STAFF REPORT
COMMUNITY DEVELOPMENT DEPARTMENT

HEARING DATE: 7/26/2022
 TO: Mayor & City Council
 FROM: Joe Dodson, Associate Planner
 208-884-5533
 SUBJECT: H-2022-0001
 Pinedale Subdivision

Annexation and Zoning of 1.22 acres of land with a request for the R-8 zoning district and a Preliminary Plat for 7 building lots and 1 common lot on 1.22 acres in the requested R-15 zoning district, by Pine Project, LLC.

B. Preliminary Plat (dated: May 2022)

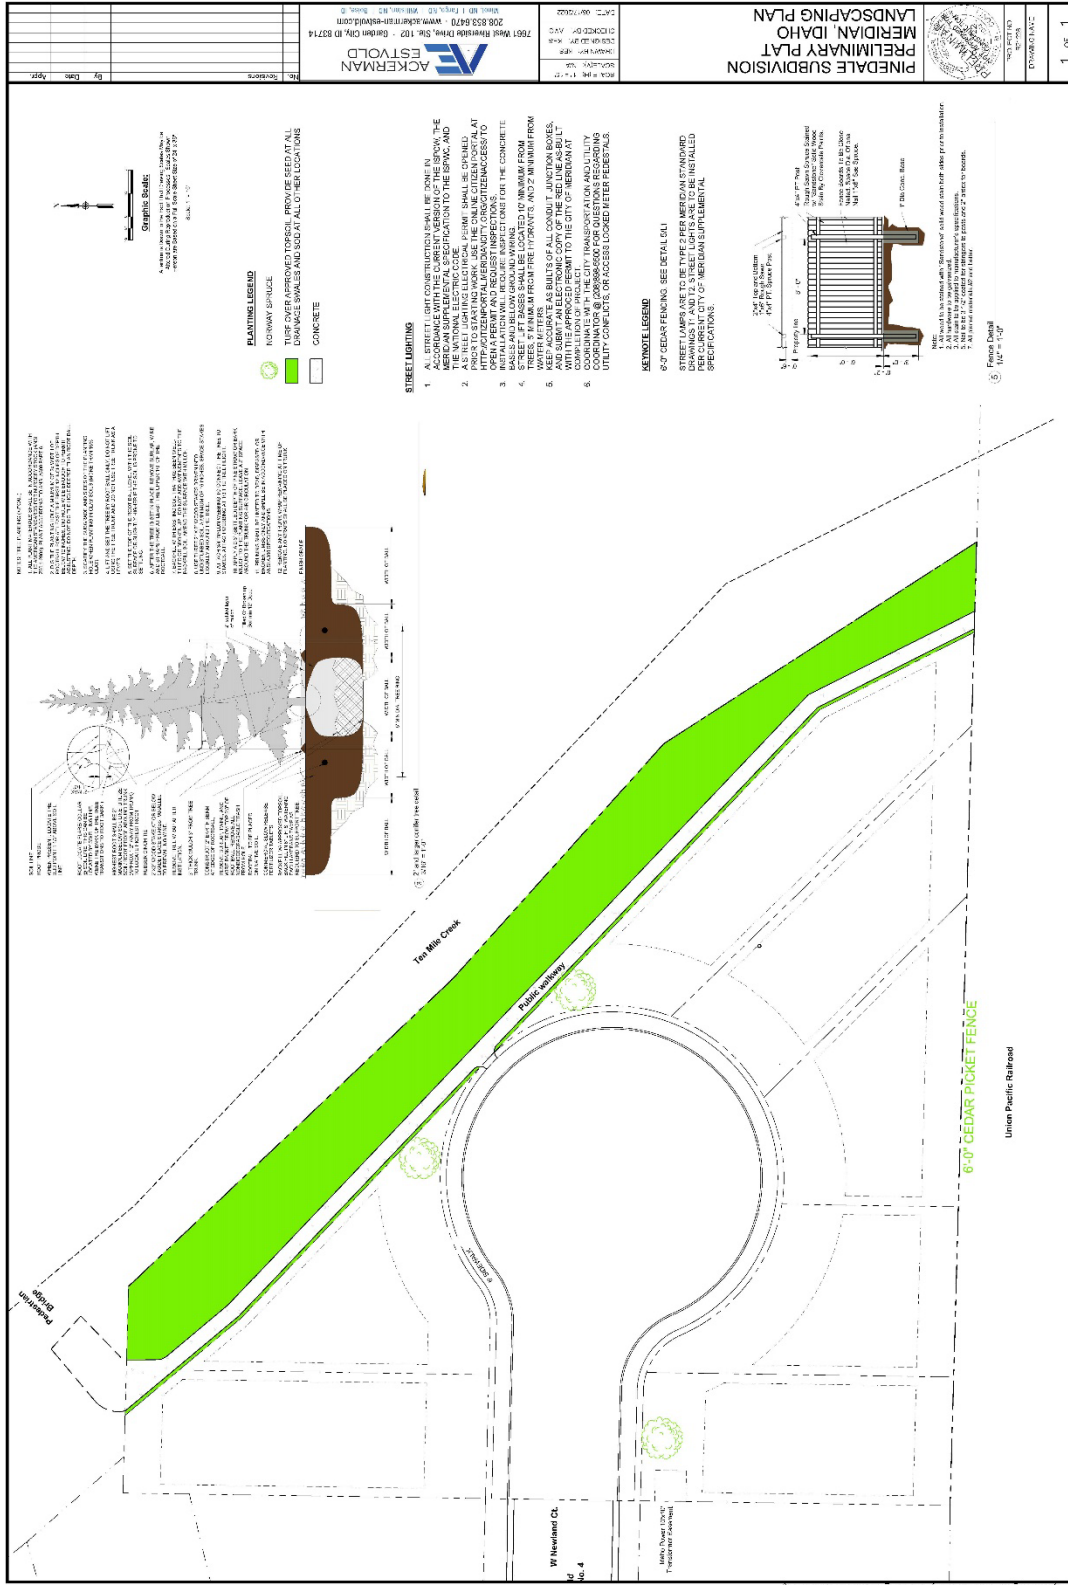
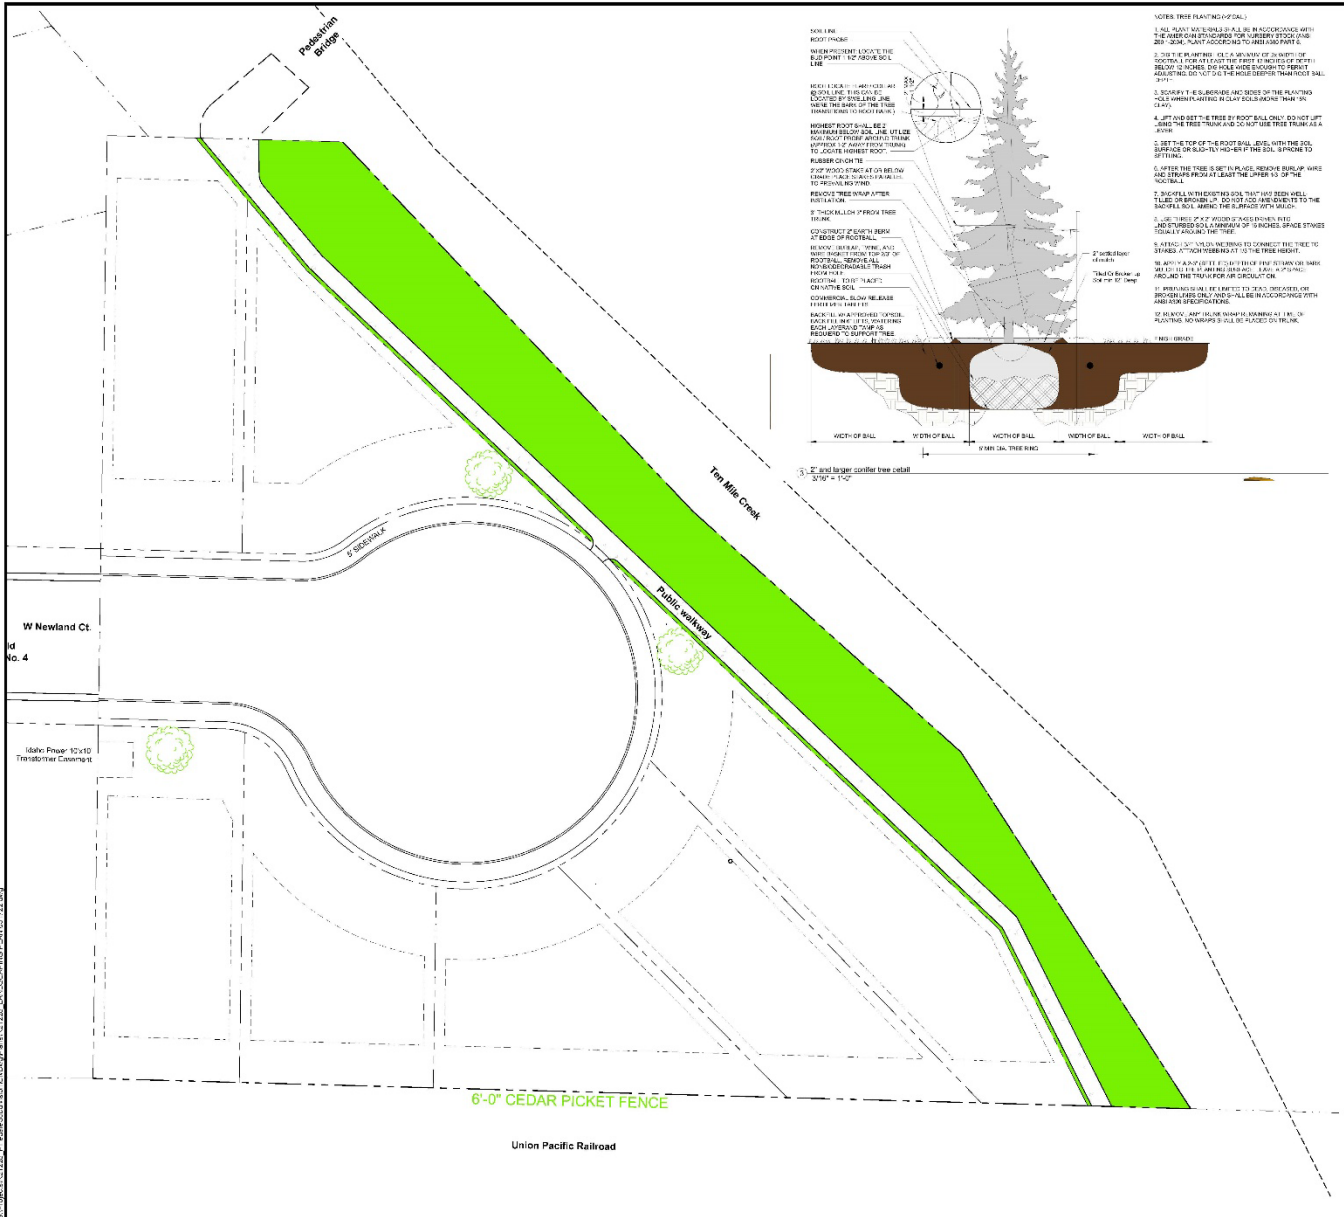
The residential lots appear to meet all UDC dimensional standards per the submitted plat. In addition, all subdivisions are also required to comply with Subdivision Design and Improvement Standards (UDC 11-6C-3). *The proposed preliminary plat and submitted plans appear to meet all UDC requirements including lot frontage and lot size. Further, the Applicant has depicted the building envelope on each lot on the plat for the purpose of showing future building footprints. As noted, the Applicant is anticipating constructing smaller homes than seen in recent years and smaller than those within Chesterfield. In addition, the setback lines on Lot 2 do not depict how code handles setbacks within a triangle so this building lot will have a slightly smaller building envelope than shown.*

2. The preliminary plat included in Section VII.B, dated May 2022, is approved as submitted.
 3. The landscape plan included in Section VII.C, dated May 11, 2022, shall be revised as follows prior to submitting for Final Plat approval:
